DEVON ESTATES

PROJECT: Devon Subdivision

RE: *TREE CONSERVATION PLAN ADJUSTMENT FOR TCP21-02*

PRELIMINARY
TREE CONSERVATION
PLAN - ONSITE: WEST

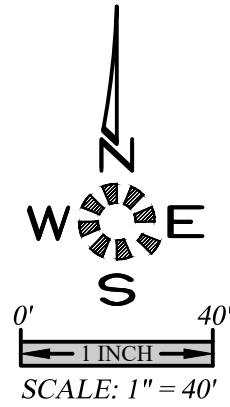
ENCLOSED IS A TREE CONSERVATION PLAN ADJUSTMENT FOR THE DEVON SUBDIVISION (SUB21-01). AFTER BEING OUT ON THE SITE, IT WAS DETERMINED THAT THE CHERRY TREE LOCATED ON LOT 5 NEEDS TO BE REMOVED. DUE TO GRADING ON THE SITE, THE FIR TREE ON LOT 37 NEEDS TO BE REMOVED AS WELL.

AFTER STARTING WORK AND GRADING ON THE SITE, IT WAS DETERMINED THAT THE CHERRY TREE ON LOT 5 AND THE FIR TREE ON LOT 37 BOTH NEED TO BE REMOVED.

AN ARBORIST REPORT DATED AUGUST 23, 2021, INDICATES THAT THE CHERRY TREE ON LOT 5 IS COVERED IN IVY WHICH IS CAUSING THE TREE TO DIE. THE TREE HAS A HIGH FAILURE RATE AND IT IS RECOMMENDED TO BE REMOVED (SEE ATTACHED ARBORIST REPORT).

Removal approved
under TCPA21-13

66 Total Trees within Boundary
17 Trees to be Preserved
49 Trees to be Removed
25.8% persevered

PRELIMINARY
TREE CONSERVATION
PLAN - ONSITE: EAST

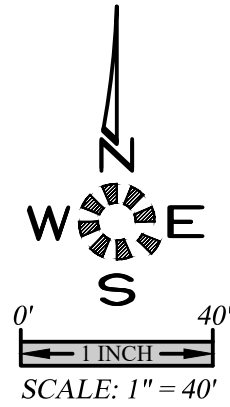
DUE TO GRADING ON LOT 37, THE FIR TREE WILL NEED TO BE REMOVED.
